EXHIBIT B

License Amendment Request dated June 24, 1983

Exhibit B consists of revised pages of Appendix A Technical Specifications as listed below:

APPENDIX A TECHNICAL SPECIFICATIONS

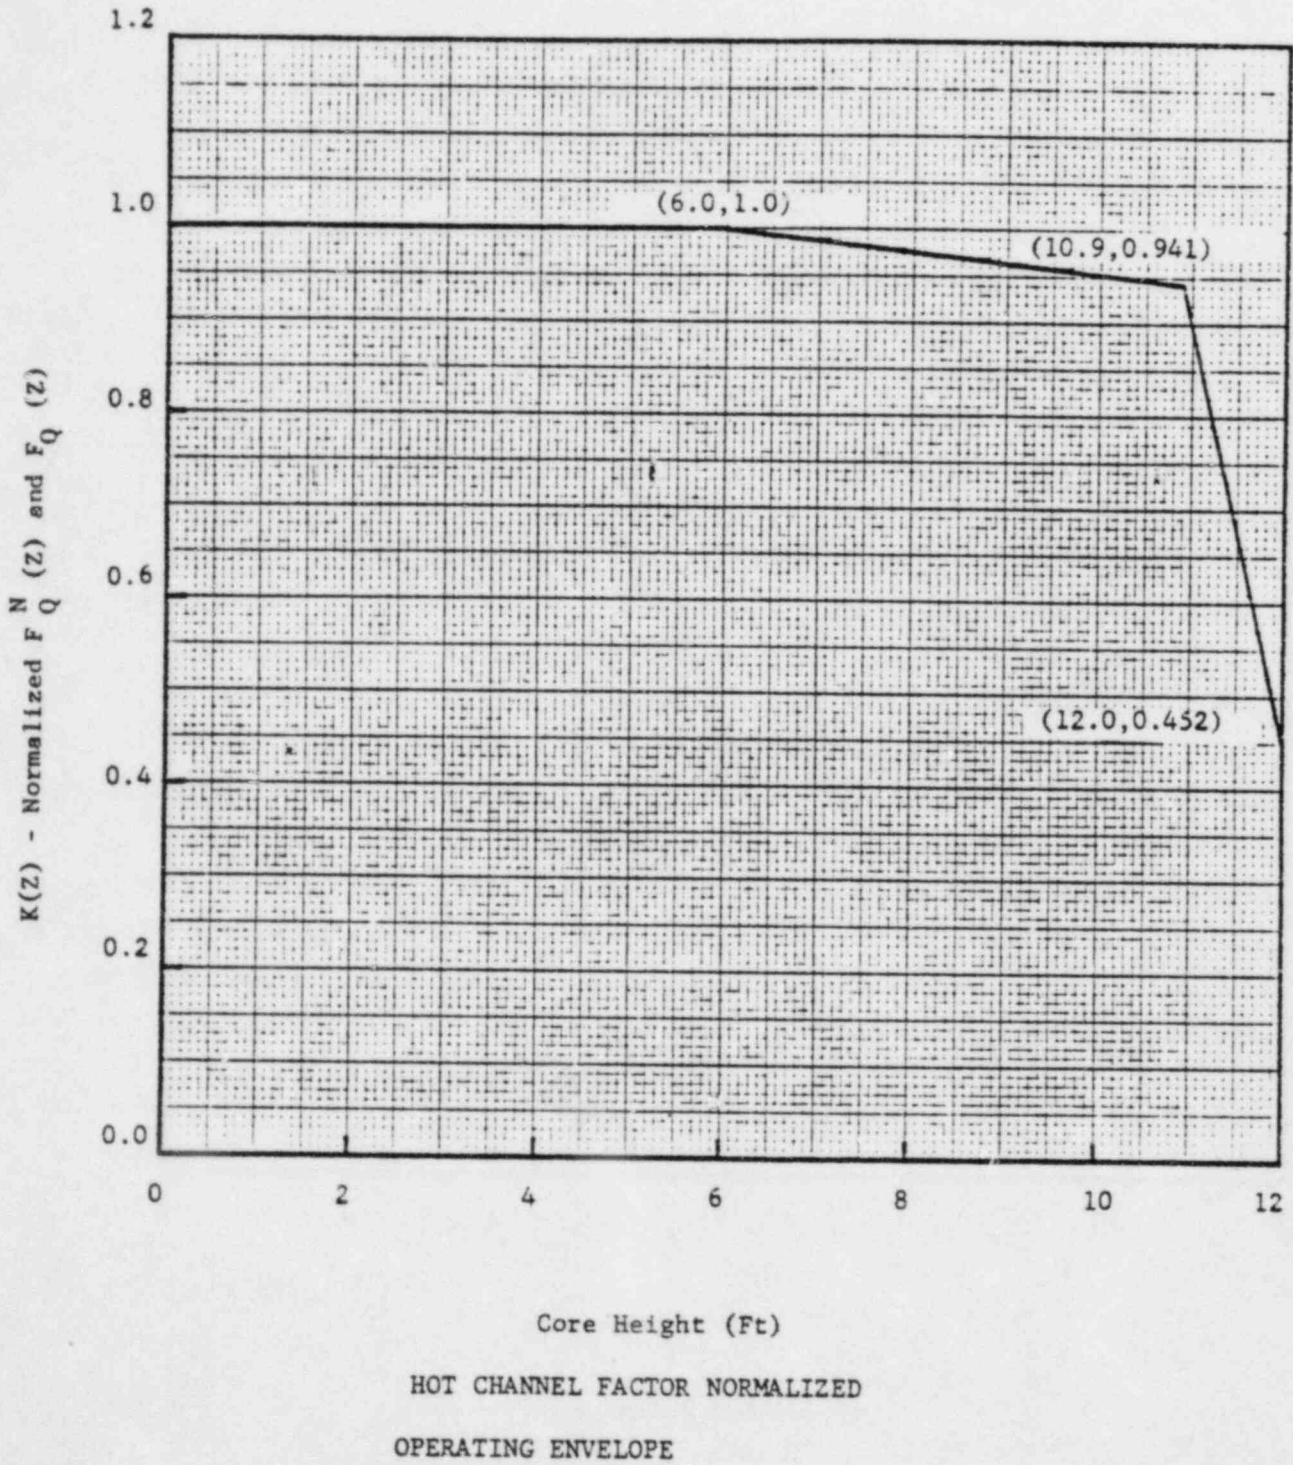
The $K(Z)$ function shown in Figure TS.3.10-5 is a normalized function that limits $F_Q(Z)$ axially for three reasons. The $K(Z)$ specified for the lowest six (6) feet of the core is based on large break LOCA analyses. Above this region the $K(Z)$ value is based on DNBR requirements since the minimum DNBR would be expected in this region of the core, based on power, pressure, and temperature. The $K(Z)$ value in the uppermost region of the core is based on the small break LOCA analyses. $F_Q(Z)$ in the uppermost region is limited to reduce the PCT expected during a small break LOCA since this region of the core is expected to uncover temporarily for some small break LOCA's.

Normalized Exposure Dependent
Function $BU(E_j)$ for Exxon Nuclear Company Fuel

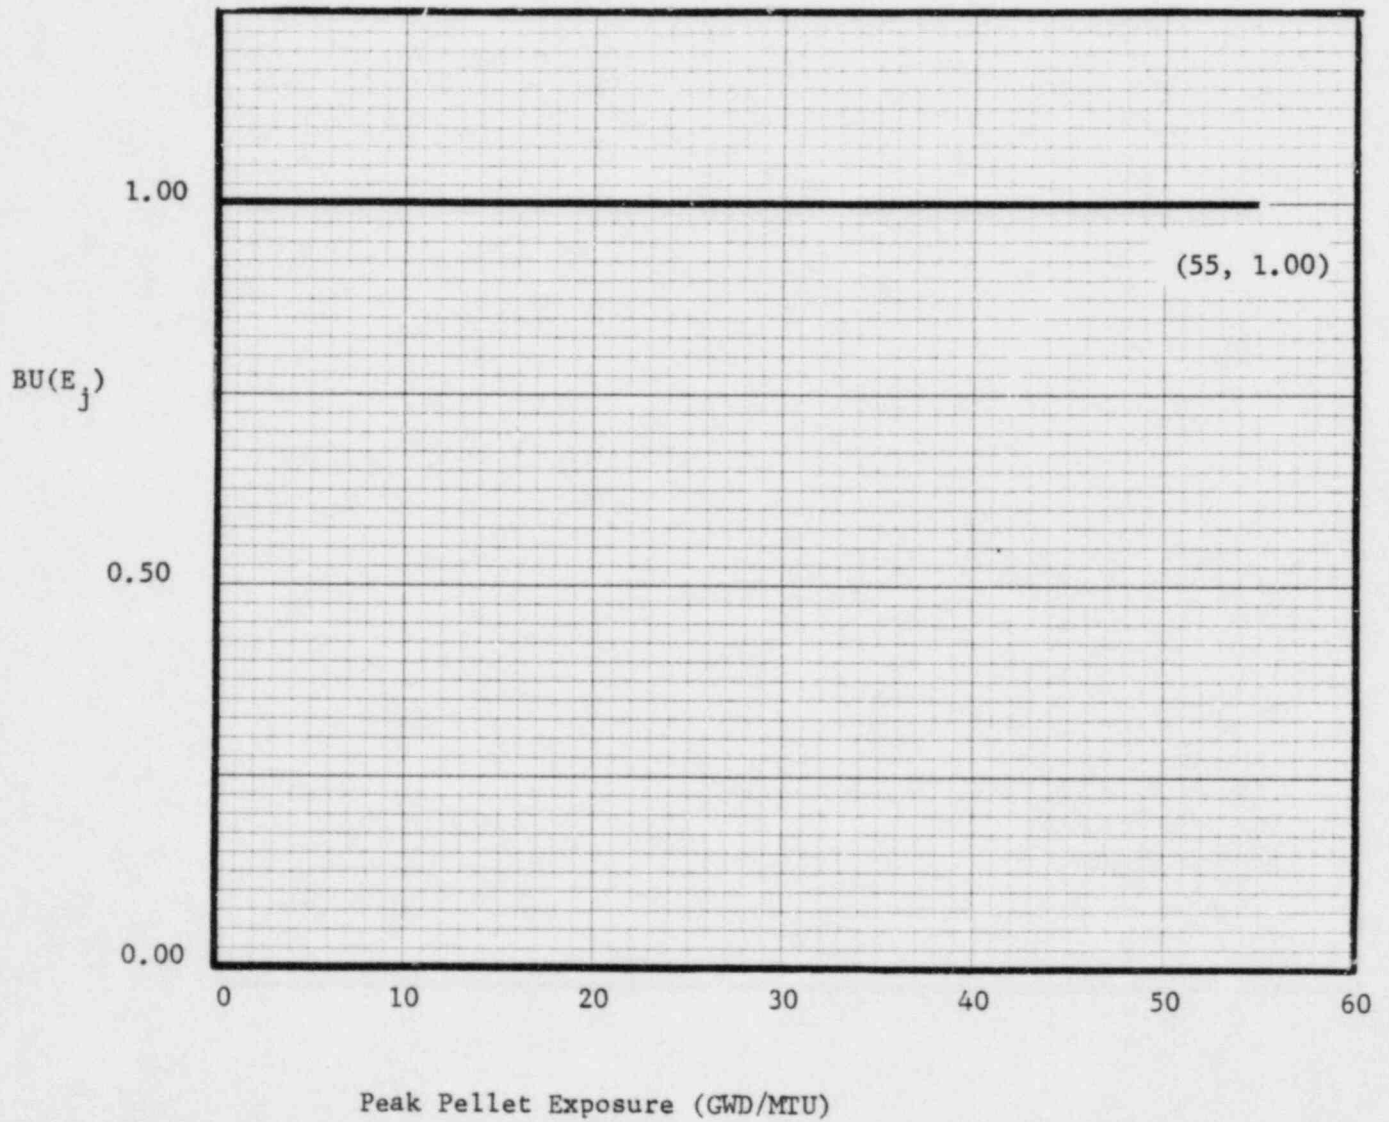
- (a) $K(Z)$ is the axial dependence function shown in Figure TS.3.10-5.
- (b) Z is the core height location
- (c) E_j is the maximum pellet exposure in fuel rod j for which the F_Q^N is being measured.
- (d) $BU(E_j)$ is the normalized exposure dependence function for Exxcn Nuclear Company fuel shown in Figure TS.3.10-7. For Westinghouse fuel, $BU(E_j) = 1.0$
- (e) P is the fraction of full power at which the core is operating. In the F_Q^N limit determination when $P \leq 0.50$, set $P = 0.50$.

The $BU(E_j)$ function shown in Figure TS.3.10-7 is a normalized function that limits $F_Q(Z)$ based on exposure dependent analyses for the ENC fuel. These analyses consider pin internal pressure uncertainties, fuel swelling, rupture pressures, and flow blockage.

The technical specifications on power distribution control assure that the $F(2)$ upper bound envelope of $2.32/P$ times Figures TS.3.10-5 and TS.3.10-7 is not exceeded and xenon distributions are not developed which at a later time, would cause greater local power peaking even though the flux difference is then within the limits specified by the procedure.
